Re: Unocal No. 5781 (351640)
3535 Pierson Street, Oakland, California
Fuel Leak Case No. RO0000253
GeoTracker Global ID #T0600101467

Attachment: Data Gap Investigation Work Plan by AECOM

**Subject: Data Gap Investigation Work Plan
Unocal No. 5781 (351640)
3535 Pierson Street, Oakland, California
Fuel Leak Case No. RO0000253
Geotracker Global ID # T0600101467**

SITE PLAN WITH PROPOSED SAMPLE LOCATIONS

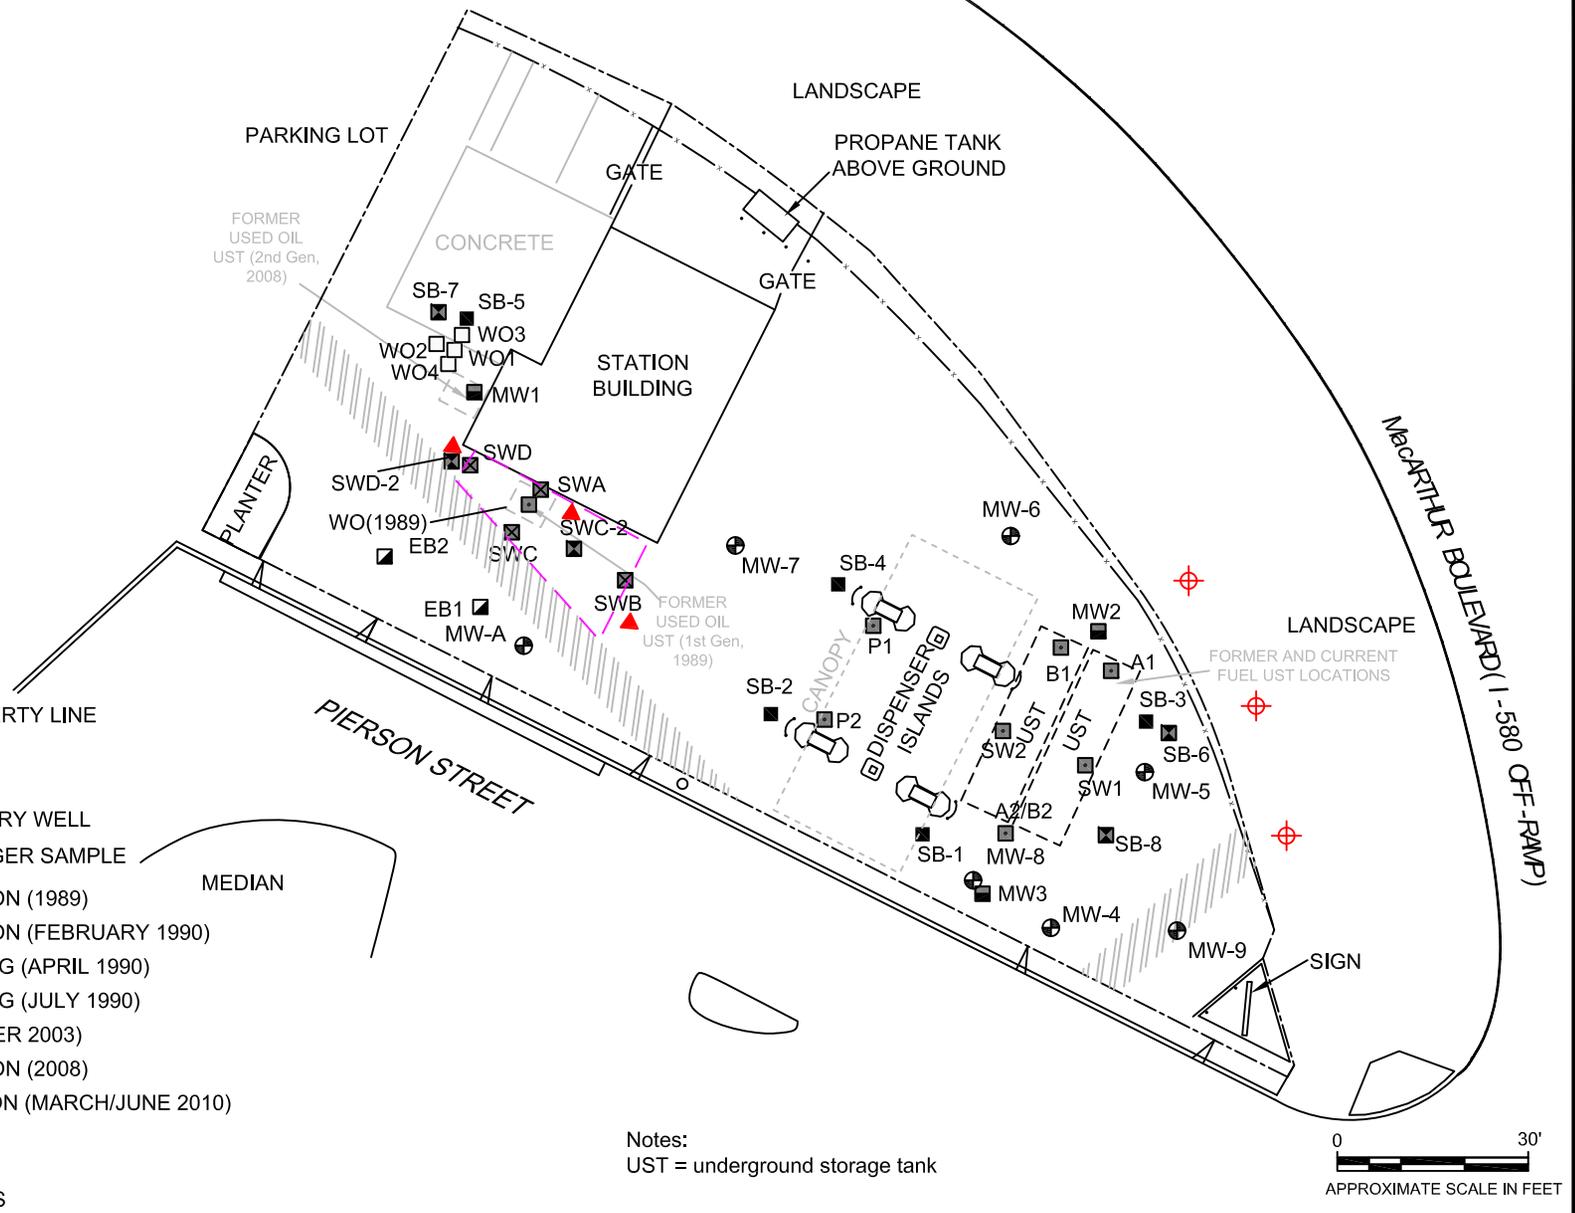
- B. Waste Oil Tank Investigation – Based on the reported presence of VOCs associated with the first generation waste oil UST, ACEH recommends the investigation (Item 1 above) include VOC analysis by EPA Test Method 8260B. Additionally, the borings should be advanced to a sufficient depth for the recovery and analysis of groundwater samples. Please collect at least one soil sample from within the 0- to 5-foot bgs zone and from the 5- to 10-foot bgs zone from each of the two borings to satisfy the LTCP Media Specific Criteria for Direct Contact and Outdoor Air Exposure.

- C. Contaminant Plume Delineation -- The installation of the three proposed temporary wells appear to address the groundwater scenario for when the flow crosses the proposed trough. ACEH recommends the groundwater investigation include an evaluation to validate the trough concept. The investigation should include at least one temporary well located to the east, as groundwater exiting in this direction has the potential of impacting the Julia Morgan School for Girls located to the east across MacArthur Boulevard.
- a. Response: The proposed temporary wells have been shifted outward to the east and will assess the impact potential for the Julia Morgan School.”

- B. Waste Oil Tank Investigation – Based on the reported presence of VOCs associated with the first generation waste oil UST, ACEH recommends the investigation (Item 1 above) include VOC analysis by EPA Test Method 8260B. Additionally, the borings should be advanced to a sufficient depth for the recovery and analysis of groundwater samples. Please collect at least one soil sample from within the 0- to 5-foot bgs zone and from the 5- to 10-foot bgs zone from each of the two borings to satisfy the LTCP Media Specific Criteria for Direct Contact and Outdoor Air Exposure.

- C. Contaminant Plume Delineation -- The installation of the three proposed temporary wells appear to address the groundwater scenario for when the flow crosses the proposed trough. ACEH recommends the groundwater investigation include an evaluation to validate the trough concept. The investigation should include at least one temporary well located to the east, as groundwater exiting in this direction has the potential of impacting the Julia Morgan School for Girls located to the east across MacArthur Boulevard.

AECOM proposes to advance three soil borings near the former first generation waste oil tank (**Figure 2**). The soil borings will be advanced using hand-auger techniques to 10 feet below ground surface (bgs). AECOM will collect discrete soil samples from 2, 5, and 10 feet bgs. AECOM's field geologist will continuously log the soil lithology, record photoionization detector (PID) readings, and other field data under the supervision of a professional geologist.

AECOM proposes to advance three soil borings east of MW-5 (**Figure 2**). The borings will be advanced using hand-auger techniques to 8 feet bgs and then advanced with direct push technology to approximately 20 feet bgs for hydropunch groundwater sample collection. AECOM

- a. Response: Three soil samples around the former first generation waste oil tank are proposed on the attached figure. We concur with the 0 to 10 foot soil sampling strategy and collection of VOCs to satisfy the LTCP Media Specific Criteria for Direct Contact and Outdoor Air Exposure. However groundwater sampling is not warranted as borings EB1 and EB2 groundwater samples, collected at 33.5 and 37.7 feet respectively, contained low TPH and BTEX compounds and were non-

detect for all other VOCs. In 2010 SWC-2 was advanced in the area of the waste oil tank, groundwater was encountered and a sample was collected at 13 feet below grade, TPHd was the only analyte detected. Even though a full VOC suite was not analyzed the lack of detectable BTEX compounds makes the significant presence of other VOCs unlikely. The horizontal extent of impacted soil is generally well characterized around the former waste oil tank through samples EB-1 and EB-2, MW-A, MW-1, and MW-7. The three soil borings will characterize the remaining soil concentrations inside the area of impacted soil.
